Access Compliance Report

Public Rights-of-Way

(Curb Ramps)

Intersection ID: 13752	Main Street: RENSSELAER_AV	Cross Street: SOUTH_BV	Location:	N
ADA ID: 968DD0A74BE4	Ramp Type: Perp	Initial Pass/Fail: Pass	Overall Compliance: No	Severity Score: 2.5
Codes/Mitigation Info/Possible Solution		Field Measurements/Component Compliance

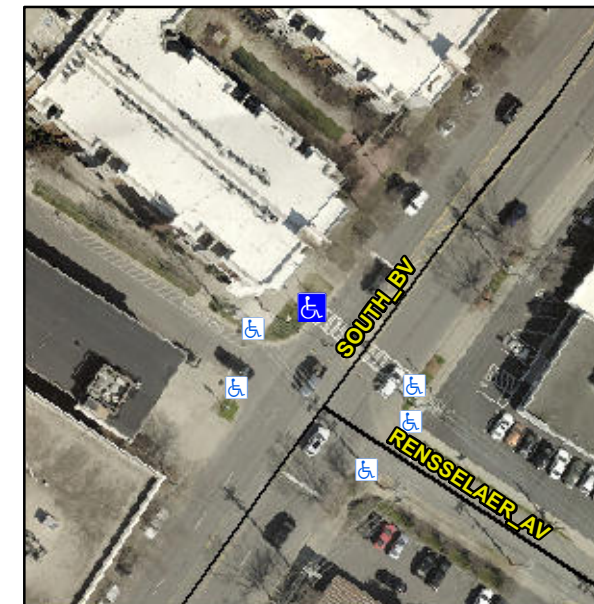
Possible Solutions:

Remove & Replace Detectable Warning System.

PROW/ADA:

R305.1.4
